**ADDENDUM NO. 2****DATE:** July 15, 2026**PROJECT:** Ground Storage Tank
Sardis Water Association**BID DATE:** July 28, 2026, 1:00 PM

ITEM #2: Specifications – 221219 – Prestressed Concrete Water Storage Tank

BID SET
GROUND STORAGE TANK
TANK PLAN & ELEVATION

JOB NO.	26004
SHEET NO.	7

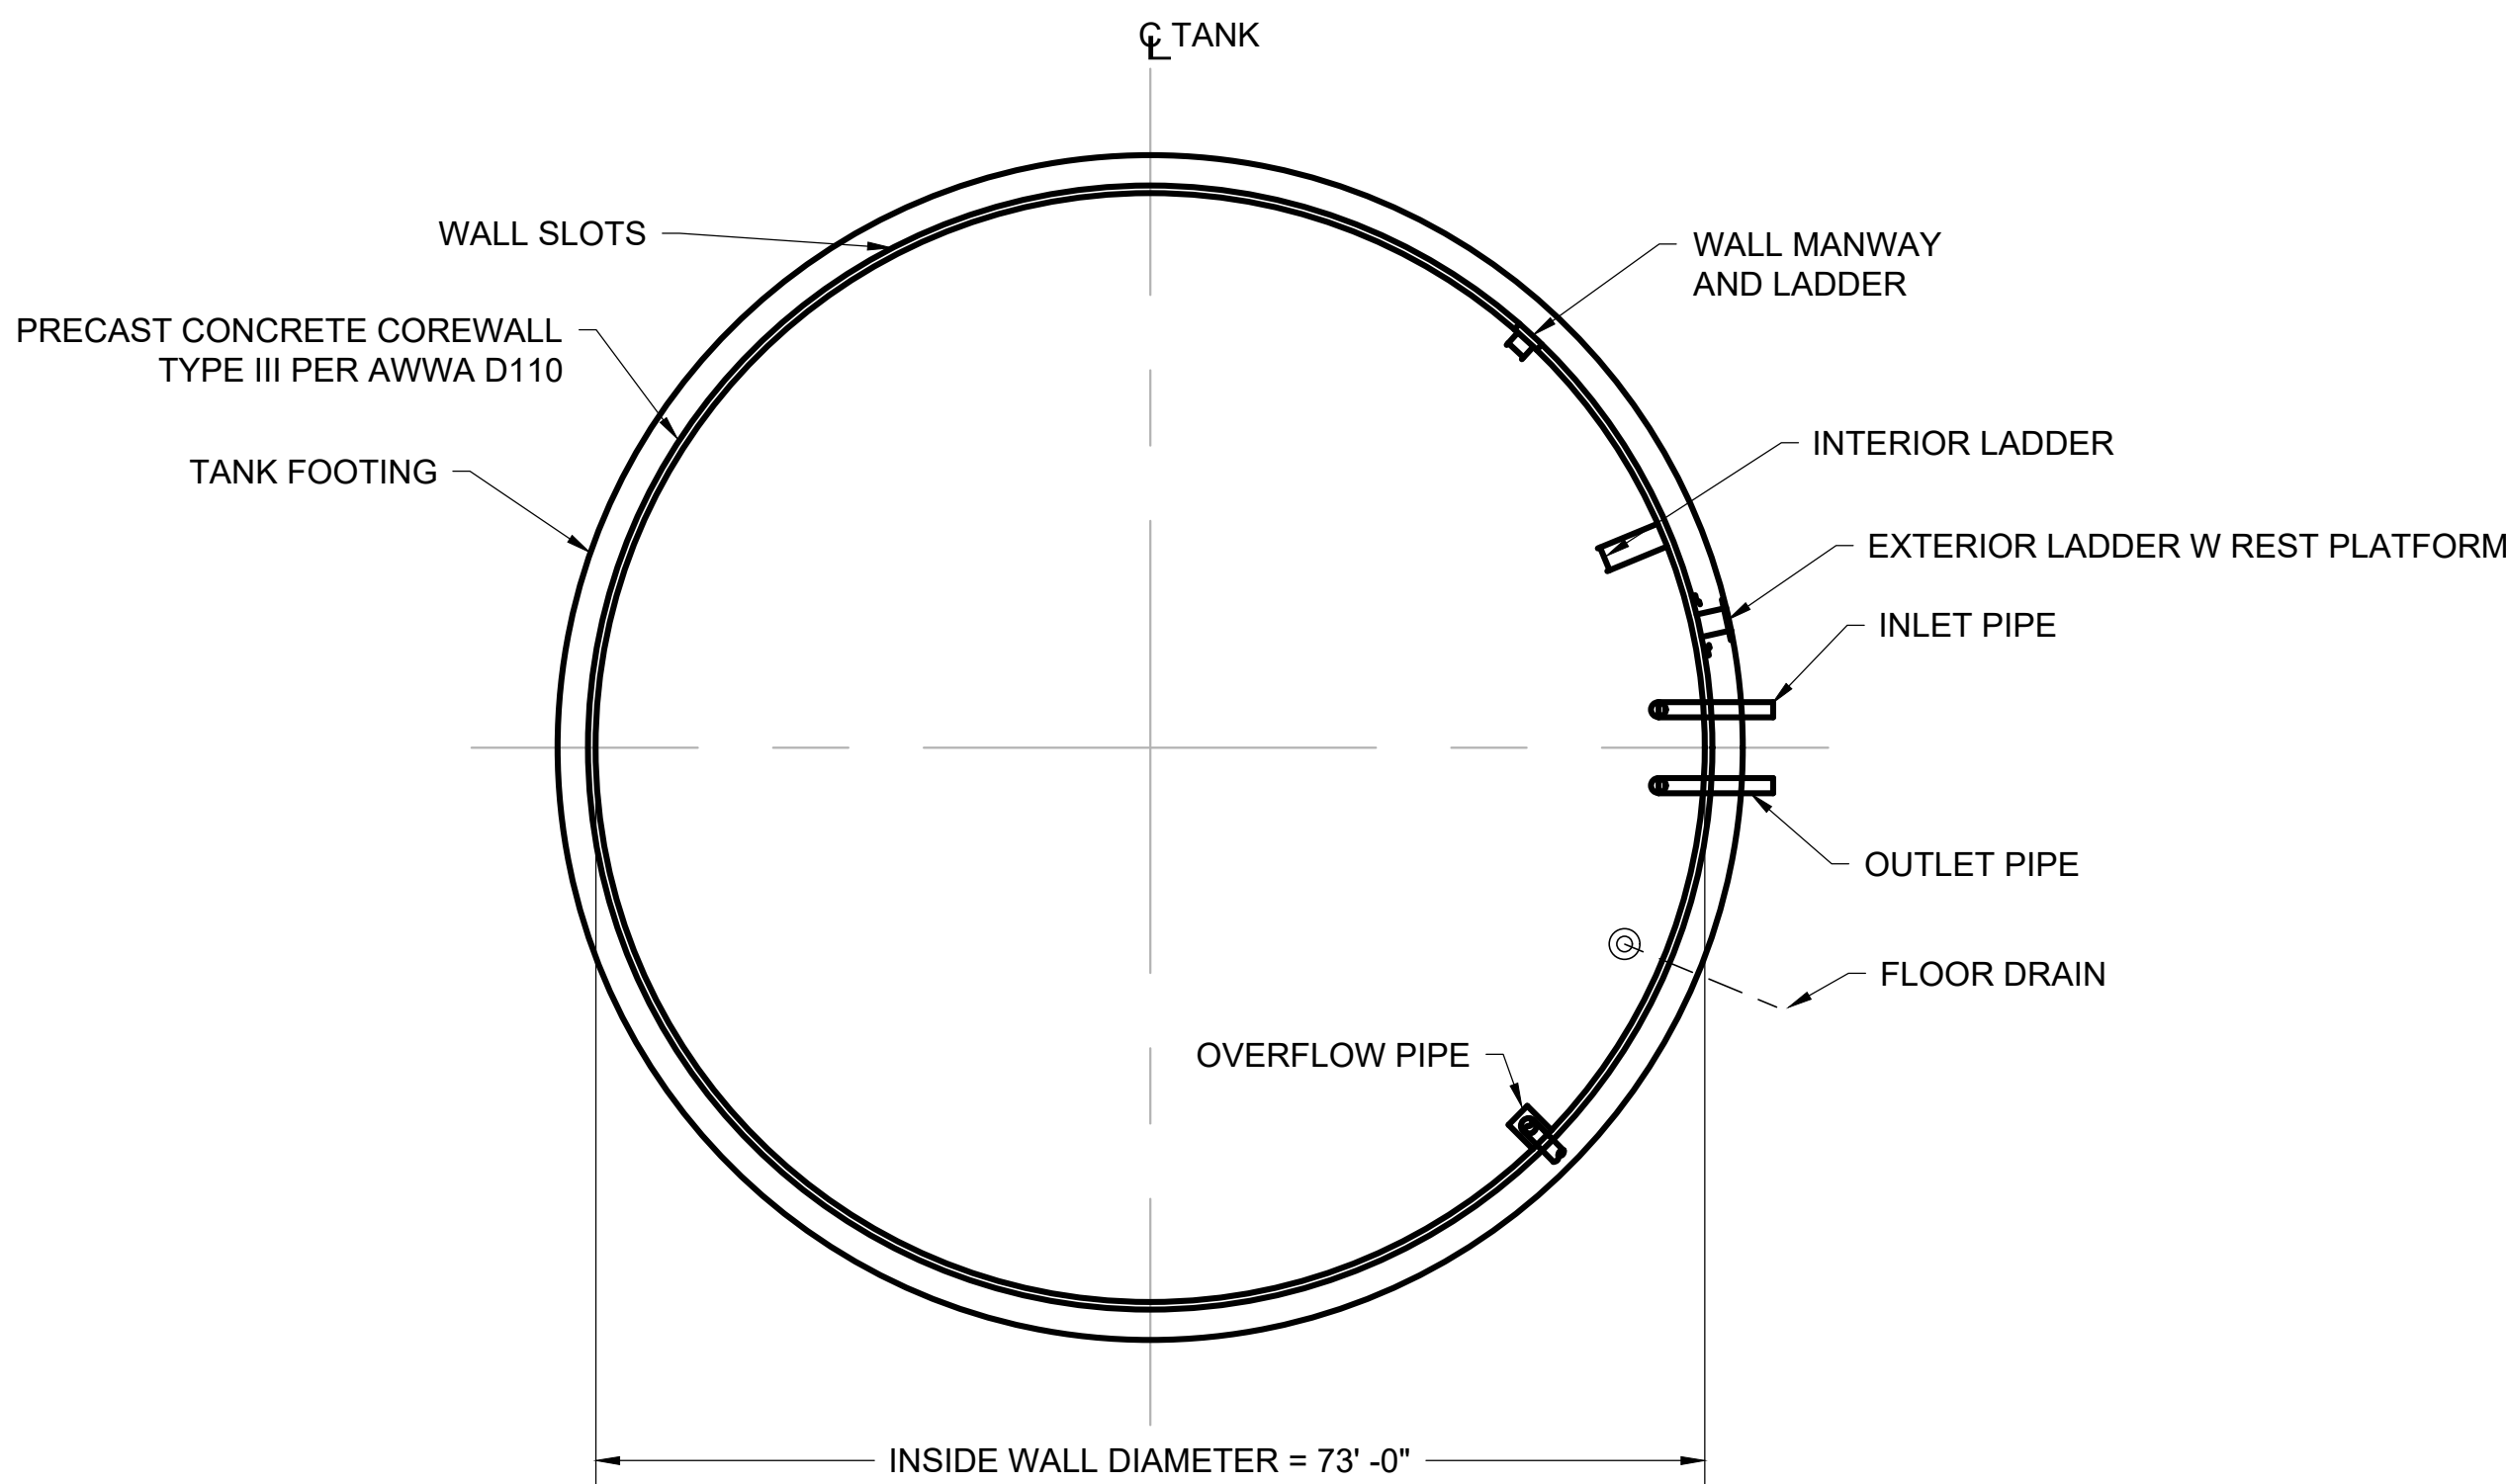
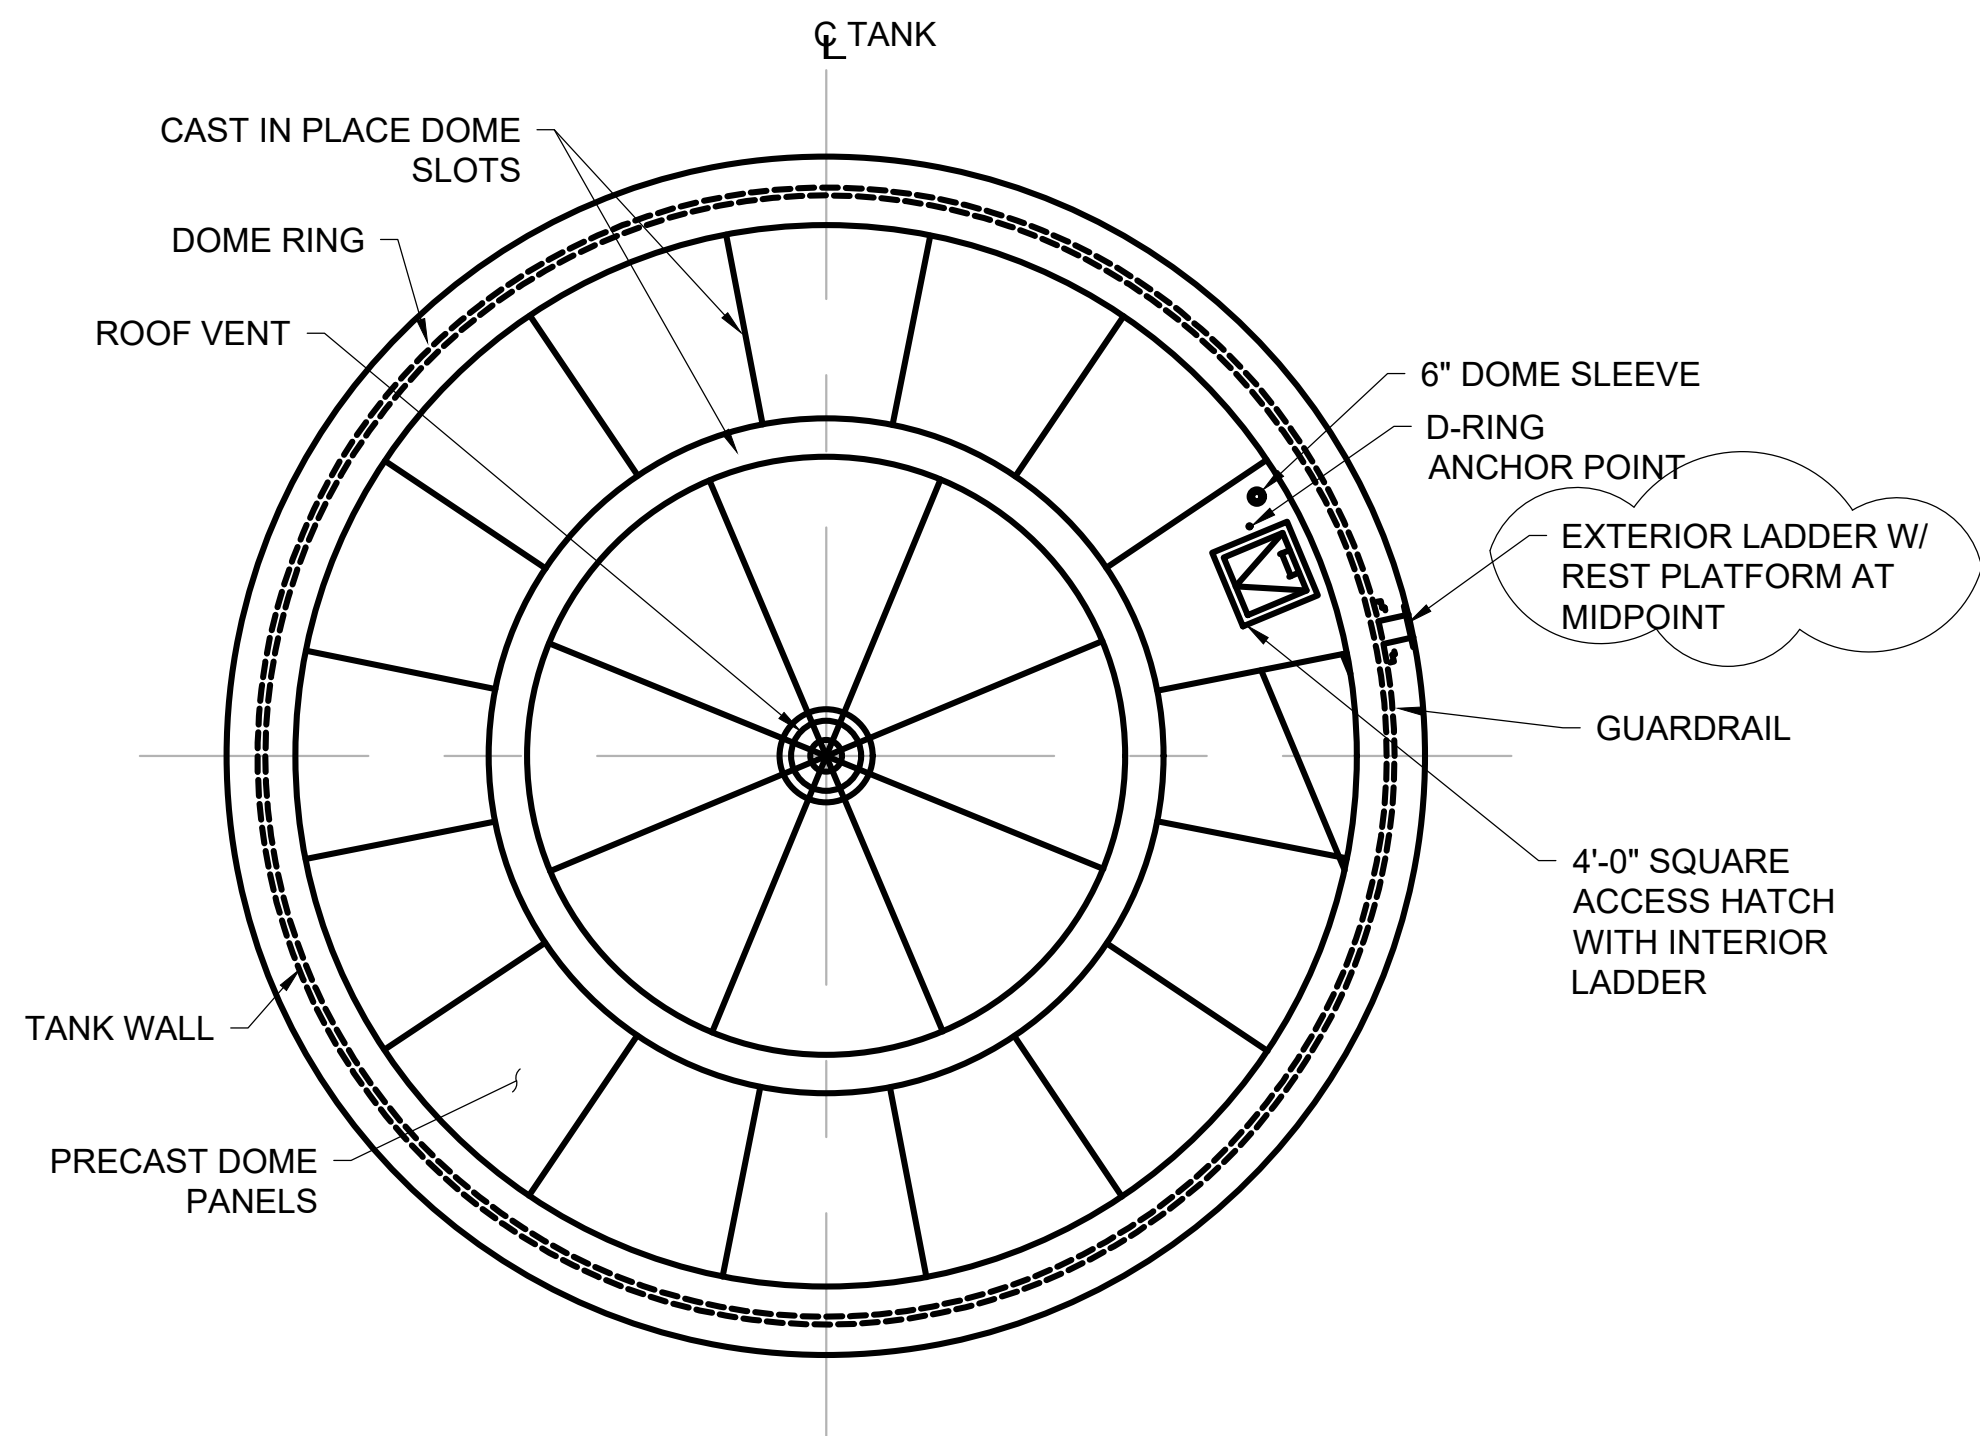
ITEM #5: Drawings – Revised Sheet 7

See revised sheet 7 for the following:

1. Logo Information
2. Undercut requirements per Geotechnical Report
3. Removed 1-foot minimum thickness for tank floor.
4. The rest platform is to be located at the midpoint height of the exterior ladder.
